Re: Approval of a two year extension of the Preliminary Plat of Kauth's Second Addition.

Re: A request by Robert Kauth for approval of the Preliminary Plat of Kauth Addition a proposed 21-lot subdivision located west of 95th Avenue and south of Hickory Hills Second Annex in part of the NE $\frac{1}{4}$ of the SW $\frac{1}{4}$ of Section 15, Buffalo Township.

STAFF REPORT

Request: Preliminary Plat of Kauth's Addition, a proposed twenty one (21) lot subdivision.

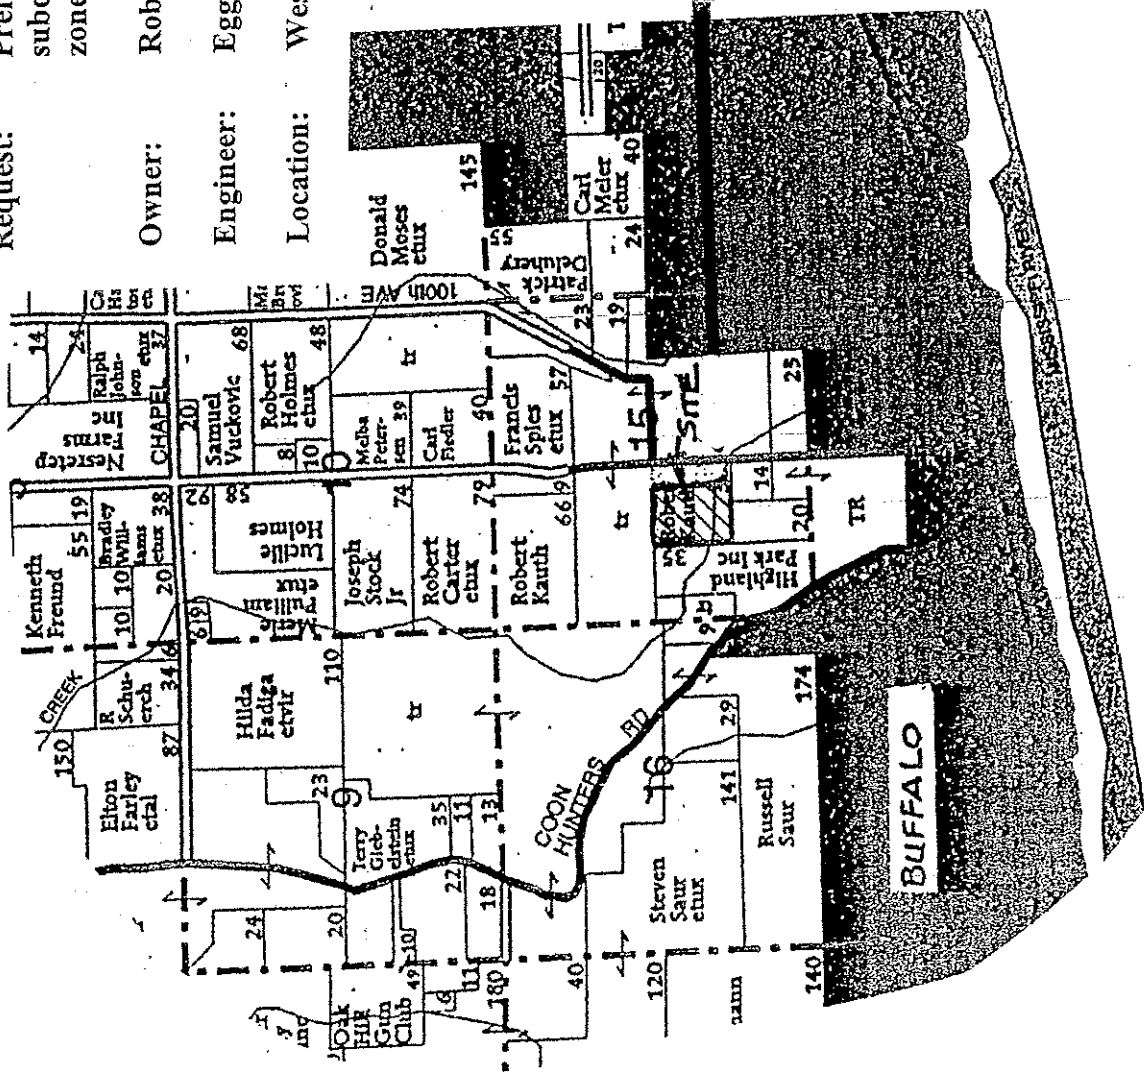
The plat has been amended to address the concerns of staff and the Planning Commission with the previous configuration that proposed four lots to be platted south of Dodges Creek that would have access to a shared private drive. As stated above those lots have been eliminated and the area is included with one large lot of 9.4 acres in size that contains the existing house on the property.

The other proposed streets will meet all County Road standards. The grading and design of the road for crossing the drainage area coming down from the north and on the west side of the previously platted lots would also have to be completed with this phase of the development.

The Subdivision regulations require all internal street to be adequately drained and that detention facilities adequate to capture the runoff from a twenty five (25) year rain event, calculated at post-developed flows, to be place in the subdivision. The release rate from that detention area shall not exceed the volume produced by a five (5) year event, calculated at pre-developed flows. The stormwater drainage plan and the design of detention facilities are required prior to Preliminary Plat approval. Staff would recommend that a stormwater drainage plan be submitted with the road design plans following approval of the Preliminary Plat.

As stated above, Dodges Creek runs along the south boundary of this property and a tributary runs along the west lot lines of the previously platted lots. Neither of these flowage areas is shown as a designated 100-year floodplain on the Flood Insurance Rate Maps (FIRM). The applicant's engineer has shown a 100 foot wide drainage easement being retained along the centerline of Dodges Creek.

The subdivision regulations require the submission of an erosion and sediment control plan prior to Preliminary Plat approval. A plan is included on the Preliminary Plat document. Those plans include information regarding the soil types and the specifications for temporary and permanent erosion and sedimentation control.

be mitigated by replacing one native tree of similar specie for every three trees removed. The areas of tree cover are shown on the Preliminary Plat. Staff would also recommend that building areas on each lot be designated to help ensure the protection of the tree cover and other environmentally sensitive areas such as the steep slopes. Staff would recommend that this information be submitted and reviewed prior to approval of the Preliminary Plat by the Board of Supervisors.

All residential subdivisions with fifteen lots or greater must provide a minimum area of 10,000 square feet of open space plus 2,000 square feet for every lot over fifteen. The previous portion of the property that was platted contained 6 lots but with these 21 proposed lots brings the total to 27 lots. Therefore this subdivision needs to provide approximately .78 acre of common open space. There is just over an acre of "nature area" shown on the plat adjacent to Dodges Creek. The Planning Commission will have determine whether this meets the requirement.

1. All grading and construction comply with the erosion and sediment control plan as approved by the County Engineer and the Natural Resources Conservation Service;
2. That permitted areas for residences and accessory buildings be shown on the Final Plat;
3. The County Engineer review and approve all street construction plans prior to construction; and
4. The subdivision infrastructure improvements be completed or a surety bond posted prior to Final Plat approval.
